UNITED STATES PATENT AND TRADEMARK OFFICE

10/520,038

Office Action Summary	Application No. 10/520,038	Applicant(s) WEITZER, WILFRIED	
	Examiner JAMES J. BUCKLE JR	Art Unit 4155

DETAILED ACTION

Reproduced from DE19933343 (Examiner Amended)

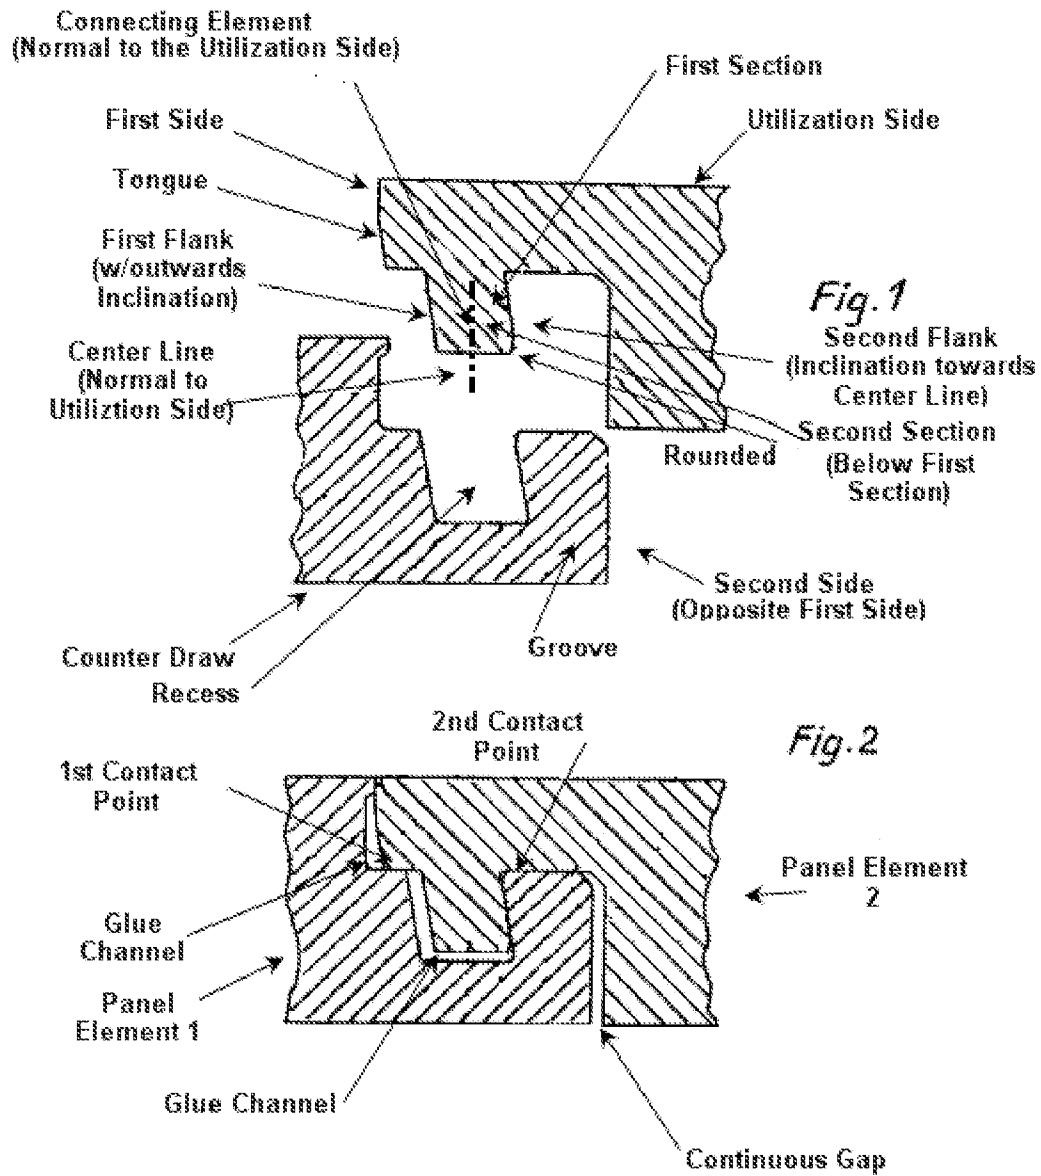
(b) the invention was patented or described in a printed publication in this or a foreign country or in public use or on sale in this country, more than one year prior to the date of application for patent in the United States.
2. Claims 1-12 are rejected under 35 U.S.C. 102(b) as being anticipated by Otto et al. (DE19933343).
3. Regarding claims 1-4, Otto et al. (Fig.1, Examiner amended)

discloses a panel element comprising a **utilization side, a counter draw opposite the utilization side, a first side having a tongue, a second side which is located opposite the first side and has a groove with a contour opposite to that of the tongue, the tongue having a connecting element which extends substantially normal to the utilization side and whose cross-section has a first flank and a second flank opposite the first flank, the cross-section of the connecting element having a first section and a second section essentially parallel to the plane of the utilization side, wherein the first section is positioned near the utilization side and the second section positioned below the first section and having a center line normal to the utilization side and viewed in the direction of utilization**

side the inclination of the first flank and the second flank each points from the center line outwards in the first section of the connecting element and in the second section the inclination of the first flank points from the center line outwards and the inclination of the second flank points to the center line, the distance normal to the center line being reduced between the first flank and second flank, characterized in that the first flank is arranged on the side facing away from the panel element of connecting element(Claim 1), and wherein the inclination of the first flank and the inclination of the second flank are substantially constant in the first section(Claim 2). The first flank has an angle inclination smaller in the first section than that of the second flank in the first section(Claim 3) and that the inclination of the first flank is substantially constant in the second section and commensurate with the inclination of the first flank in the first section (Claim 4).

4. Regarding claim 5, Otto et al. discloses a second flank is rounded in the second section ("Rounded", Examiner amended, Fig.1).
5. Regarding claim 6, Otto et al. further discloses a groove having a **recess with a contour opposite to that of the connecting element** and when groove is connected with tongue of another similar panel element, a

- first contact pint is formed on the first flank of the connecting element and a second contact point is formed on the second flank of the connecting element essentially opposite to the first contact point** (“Recess”, “1st and 2nd Contact Point”, Examiner amended Fig.1 and 2).

6. Regarding claims 7 and 8, Otto et al. discloses a **glue channel is formed in the recess of the groove on a surface of the recess parallel to the counter draw side** (“Glue Channel”, Examiner amended Fig.2).

7. Regarding claim 9, Otto et al. discloses a continuous gap adjacent to at least a section of the second side formed by a tongue of one panel element being connected to the groove of another similar panel element. (“Continuous Gap”, Examiner amended Fig.2)

8. Regarding claim 11 and 12, Otto et al. discloses, an interlocking floor system as set forth in claims 11 and 12 (Fig.1, Examiner amended). Examiner notes that claims 11 and 12 are virtually similar to claims 1 to 4 which have been addressed. See rejections to claims 1 to 4 above.
